SUNDRY NOTICES AND REPORTS ON WELLS

Tribal C #8-5 (PC/Dk)
SE, Sec. 5, T26N, R3W
Rio Arriba County, New Mexico

PLUG AND ABANDONMENT PROCEDURE:

CONDITIONS OF APPROVAL FOR PERMANENT ABANDONMENT

EXISTING WELL

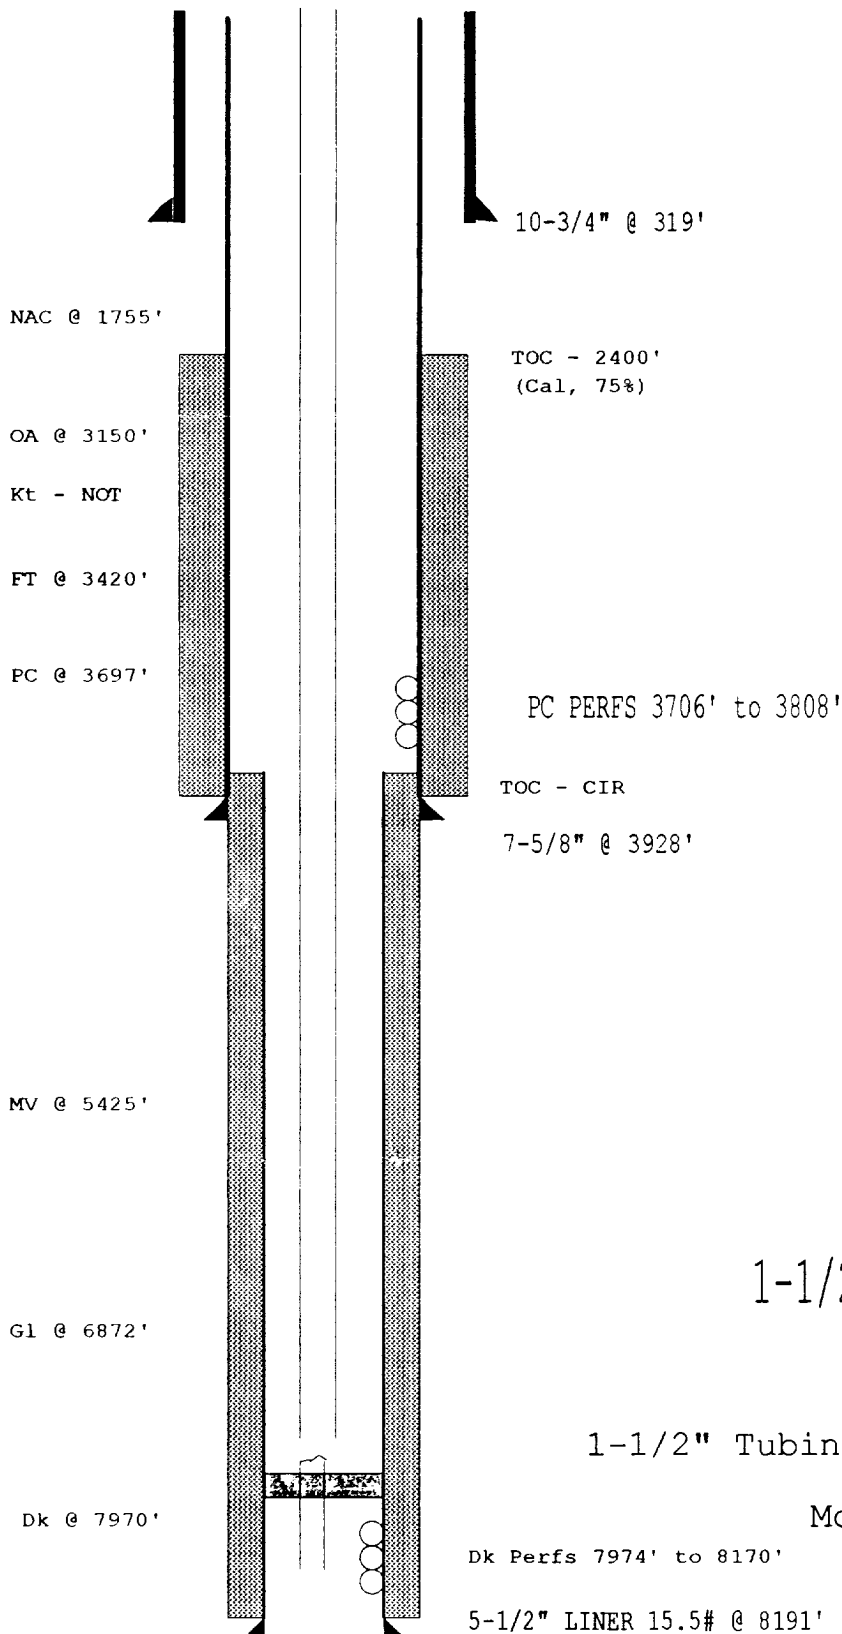
On step 9, increase the amount of cement on top of the retainer to 12 sacks so that the amount of the plug is 50 feet.
